WMMO - Replacing A-pillar Trim Panel (Stop Delivery)

Vehicle Type: **Macan (95B)**

Model Year: **As of 2021 up to 2022**

Installation position of A-pillar trim panel

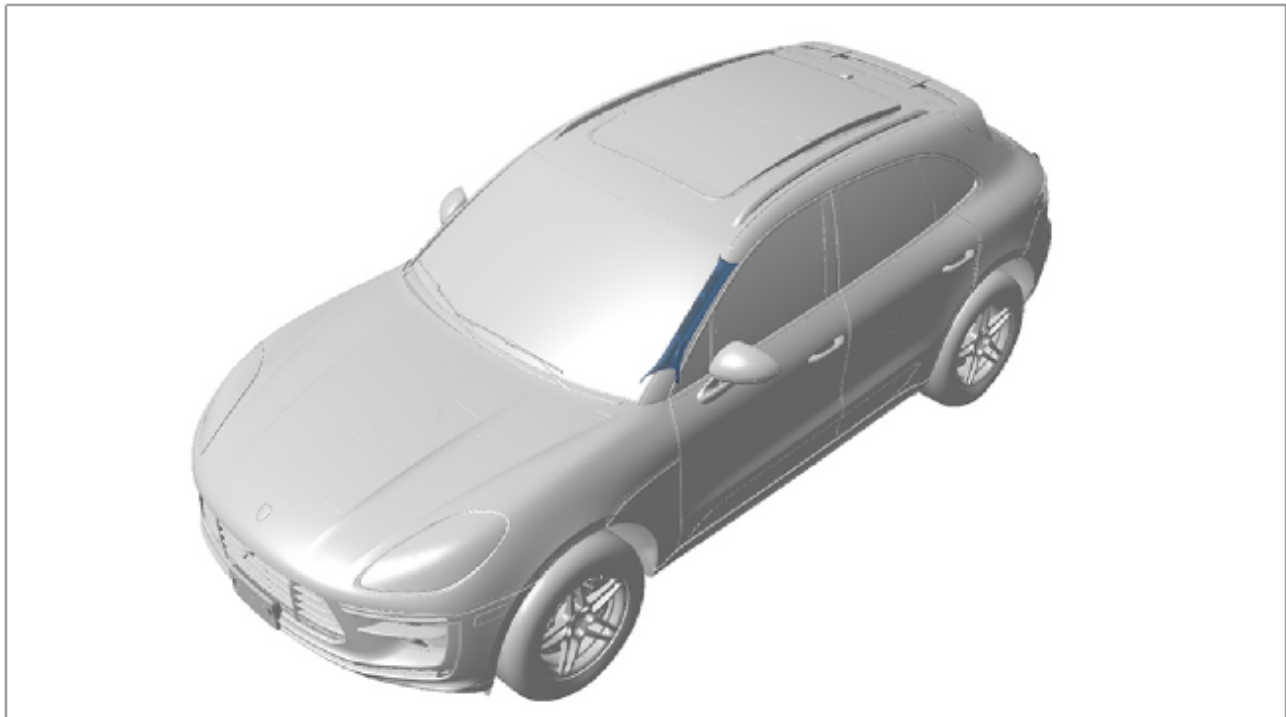
Information: **Due to a supplier error, a material that does not meet the required specifications was used for making the A-pillar trim panels on the affected vehicles.**

Action required: Replace A-pillar trim panels at the left and right.

Parts Info:	Part No.	Designation	Qty.
	95B867233E OX7	⇒ A-pillar trim panel, left	1 ea.
	95B867234E OX7	⇒ A-pillar trim panel, right	1 ea.

- 1 Replace A-pillar trim panels at the left and right.
⇒ *Workshop Manual 'Removing and installing A-pillar trim panel'*
- 2 Enter the campaign in the Warranty and Maintenance booklet.
